**Wang Engineering, INC.**  
Consulting Geotechnical & Environmental Engineers

Re: Amendment to NRC License No. 12-23526-01,  
Expiration Date 5/31/1990, Docket No. 030-28018

Amendment to 12-23526-01

Proposed Storage Area

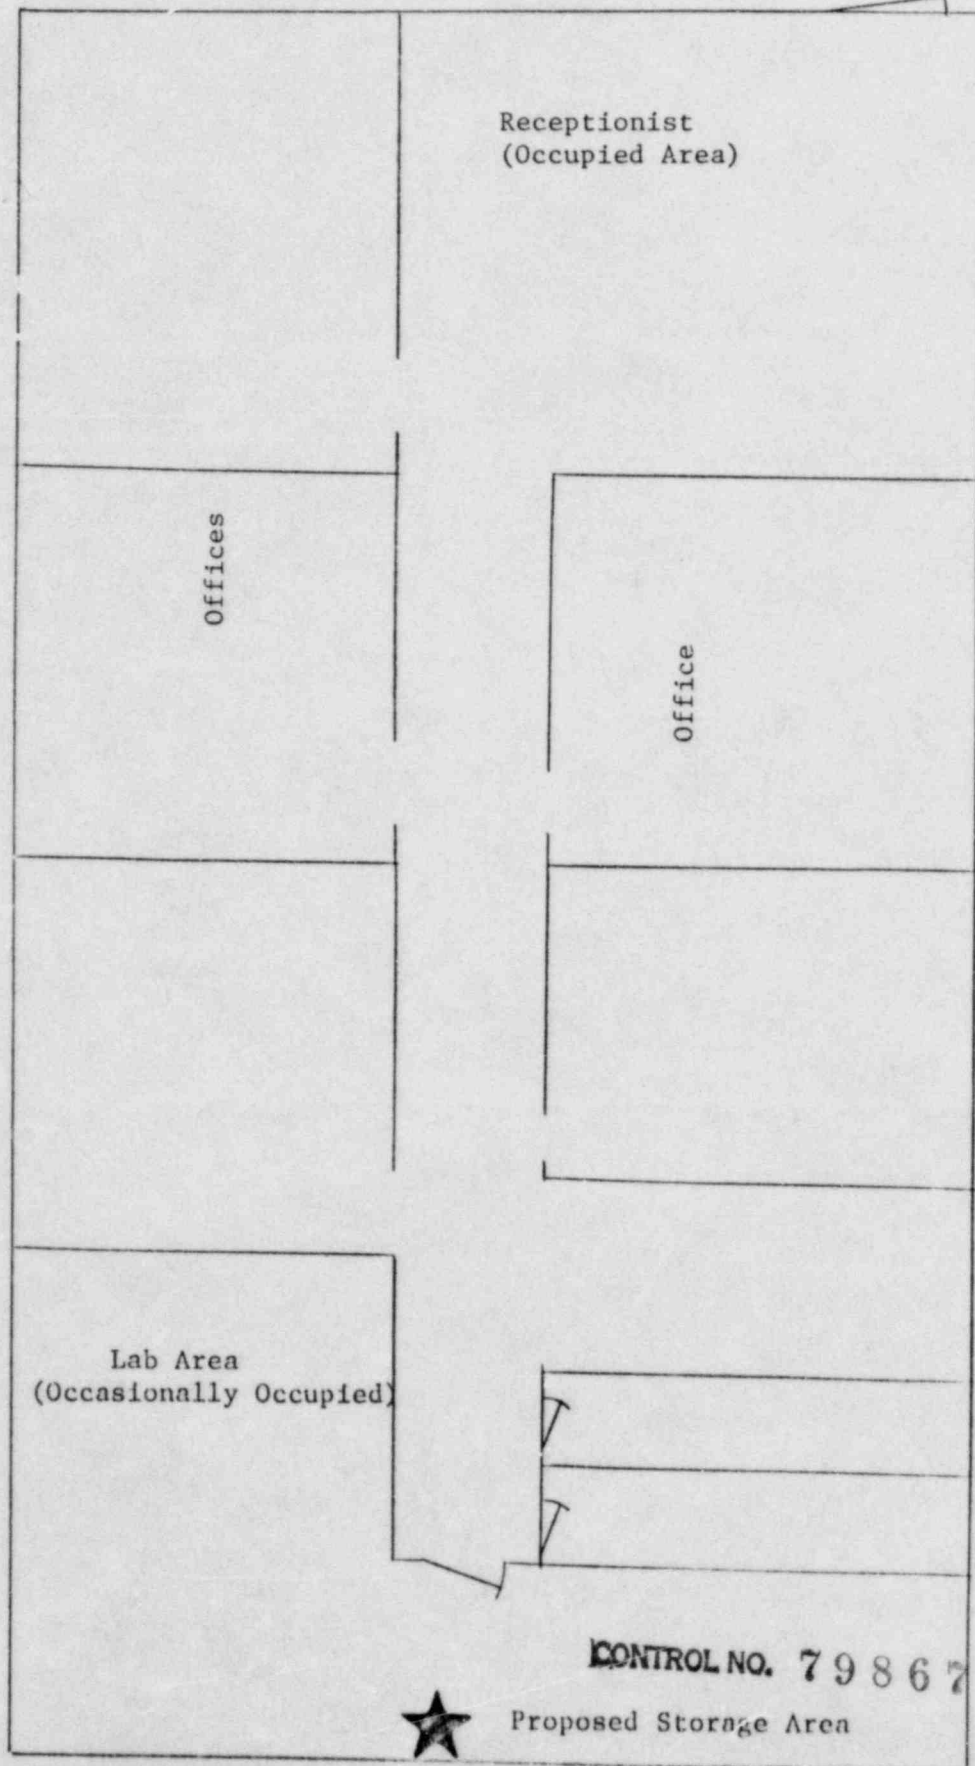
Informed licensee that they should make the statement that the device will be stored in a locked enclosure in the new location. (Room will have a lock)

Submit Commitment
